Product Change Notification

Change Notification #: 108016 - 00
Change Title: The Intel Fast Ethernet Controllers and Gigabit Ethernet Controller products

Moisture Sensitive Label Change

Date of Publication: October 25, 2007

BEFORE CHANGE. AREAS THAT WILL CHANGE ARE CIRCLED IN RED

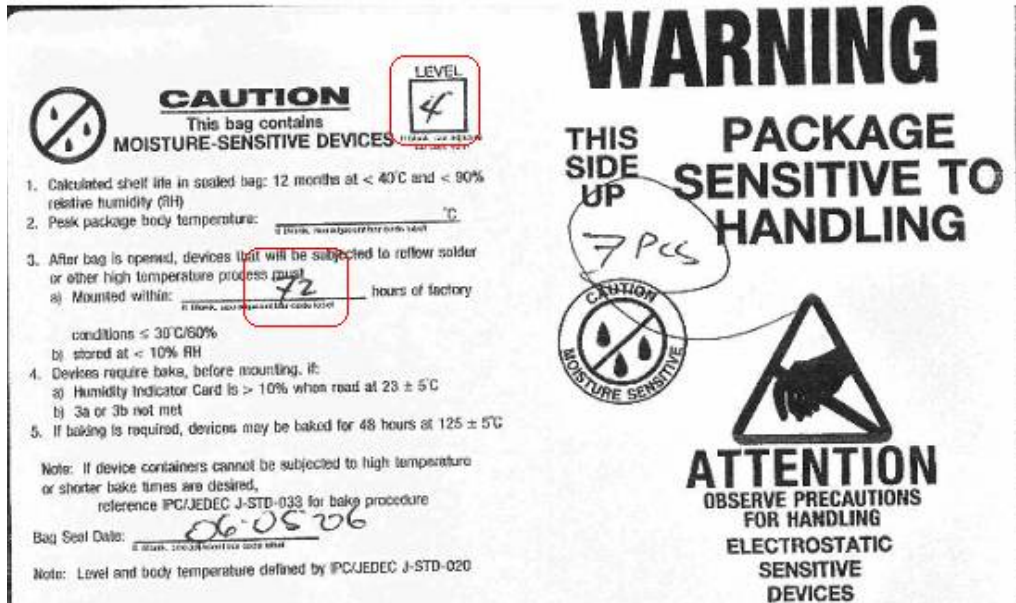
The Intel Fast Ethernet Controllers and Gigabit Ethernet Controller products as noted in the Affected Products table (see below) will undergo the following documentation change on the Moisture Sensitive Label (MSL).

The Moisture Sensitive Label (MSL), located on the outside of the static bag, will now be marked correctly. Please see the affected product table below for specific changes.

Please see the attached picture as an example of the Moisture sensitive label.

Customer is advised to follow JEDEC standards with appropriate Moisture Level as stated by product. Customers may want to notify their receiving departments of the new MSL change or update relevant internal documentation.

Customers are expected to see mixed inventory with either MSL until current inventory levels are depleted.
